Courtyard enclosure study · closing the conditioned house around the open courtyard · Taif / Palm House V6.3

Design review Y-01 (critical) · 30 Oct 2026 · the windows follow `docs/DESIGN_LANGUAGE.md` (black steel, divided lites)

DECIDED: option A (owner, 30 Oct 2026, applied on the work branch for V6.4): the projection 1.55 m, B3 / R11 / C21–C23 at x 5.80, W1 / W2 / W3 as in § 2. The "now" column below is the V6.3 state (edge x 5.60), kept as the record of the comparison.

3 · The gallery: ≥ 1.20 m clear is the constraint

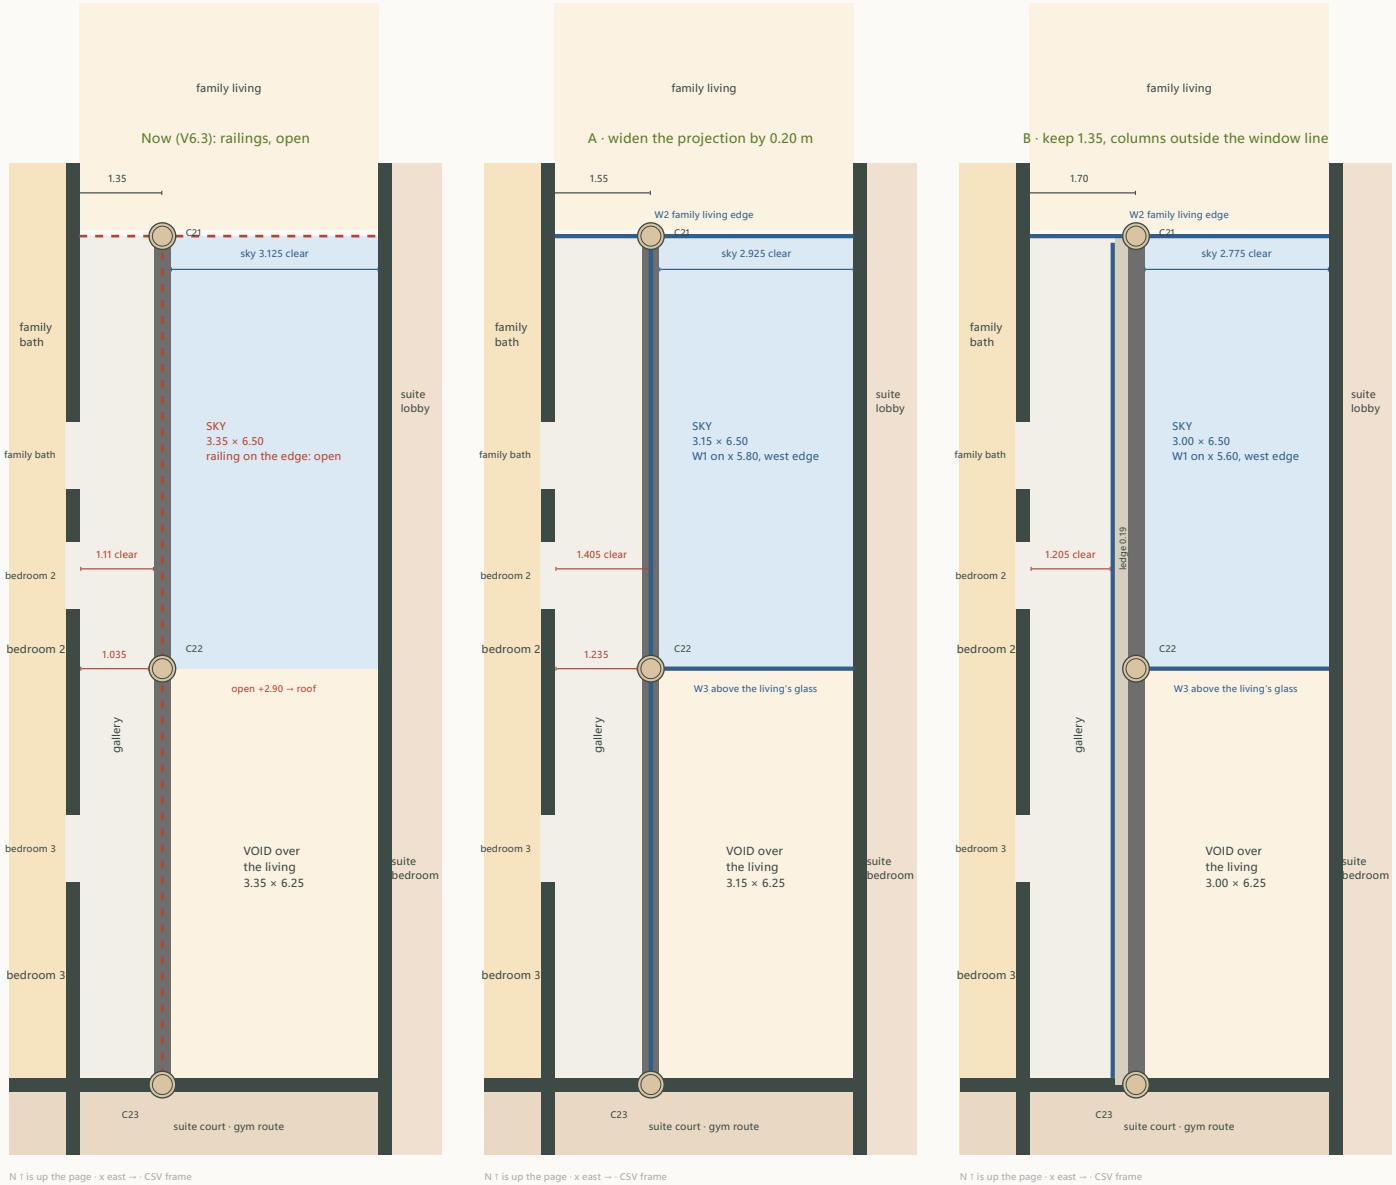
Today the gallery is 1.11 m clear between the rooms' finished wall face (x 4.365) and the upstand of B3, and 1.035 m at the three stone column sleeves (Ø0.4). A window on the line changes little by itself; the columns are the problem. Two ways to reach 1.20 m:

4 · Recommendation: A **A** keeps everything on one line: the beam, the columns, the window and the railing base are the same element, the gallery is 1.405 m clear and 1.235 m at the columns, the sky loses 6 % of its area and stays 3.15 m wide on axes. **B** reaches 1.20 m with no margin (1.205 m), narrows the sky more (3 m: the beam and the roof edge must follow the columns), and adds a 0.35 m ledge outside the glass that must be waterproofed, capped and kept clean; its one real gain, free-standing columns in front of a glass wall, is a stronger colonnade image. If the owner wants that image, B is buildable; otherwise A. In both, the two-storey columns, the upturned B3 and R11 stay as decided (X8); only their x changes. **Study checks passed** (7)

Plans of the gallery strip, first floor · now / A / B · the sky opening and the void · about 1:115 on A4

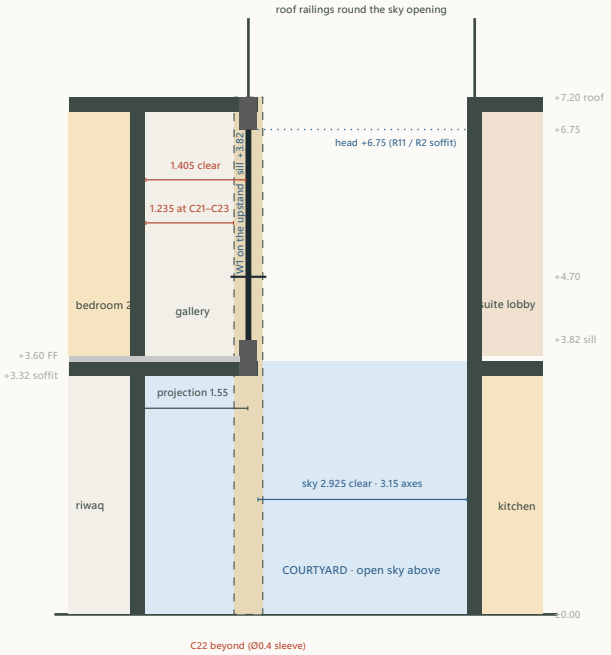
Dark: walls and the edge beam B3 (0.25 wide, upturned 0.30 above the slab). Blue lines: the new steel windows W1 / W2 / W3; red dashed: the open railings of today. Columns: the stone sleeve Ø0.4 round the Ø0.3 core. In B the beam and the columns leave the window line and a 0.19 m ledge lies between the glass and the beam (capped in stone, falling to the courtyard). The gallery doors are the V6.3 1.00 m openings.

Sections through the courtyard (y ≈ 10, looking north) · A and B · about 1:105 on A4

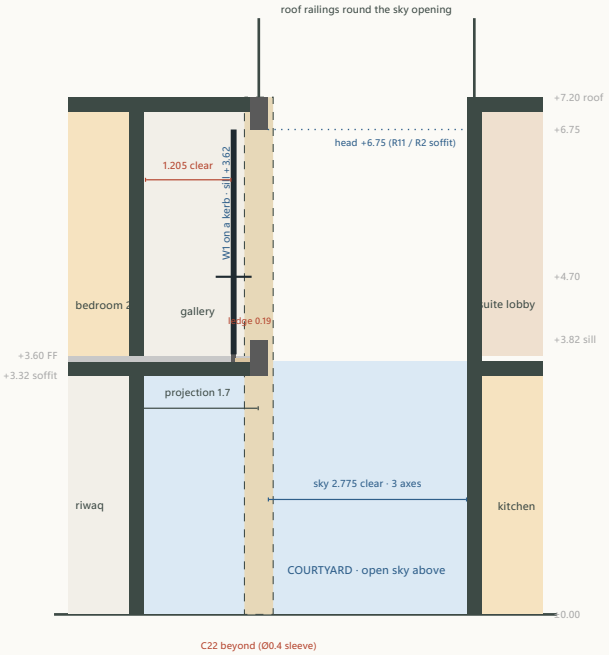
Dark: walls, slabs, the roof; grey: the upturned edge beam B3 (0.25 × 0.50 total, 0.30 above the slab) and the roof edge beam R11 above it; the dashed column is C22 (y 13.0) beyond the cut. W1 (heavy black line) sits on the upstand (A) or on a 0.10 m kerb inboard of it with a stone-capped ledge outside (B); its guarding transom at +4.70, its head at +6.75 under R11.

W1 · the gallery line seen from the courtyard and the void (looking west) · option A · 1:70 on A4

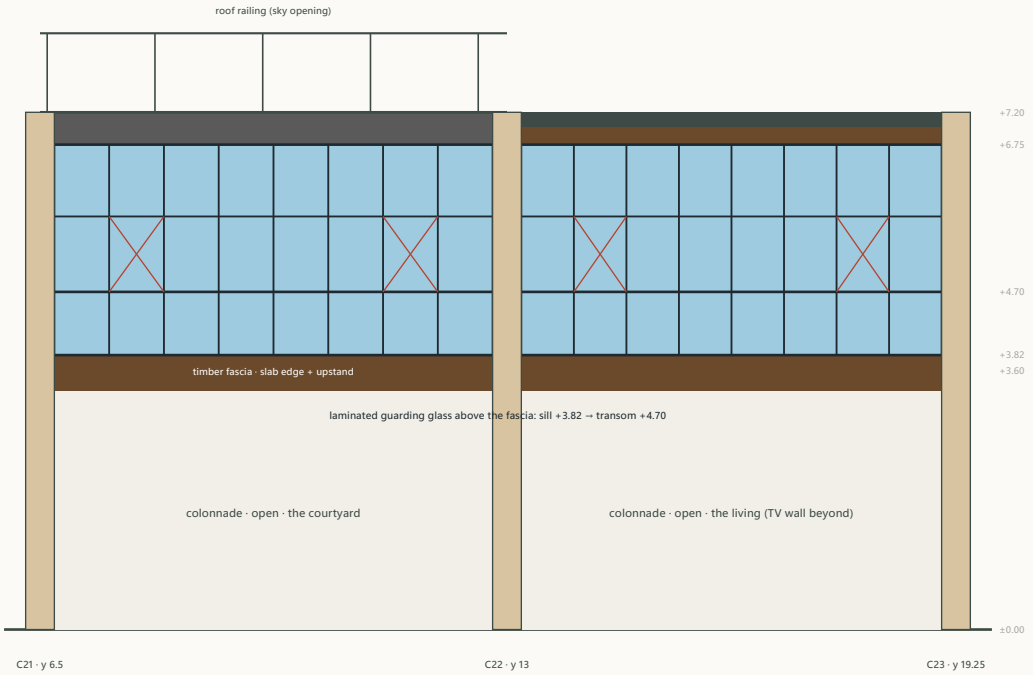
black steel, divided lites ≈ 0.75 wide · transoms at +4.70 (guarding) and +5.75 · red X = inward side-hung casements, two per bay (night mode, cleaning) · about 35.01 m² of glass · A · widen the projection by 0.20 m
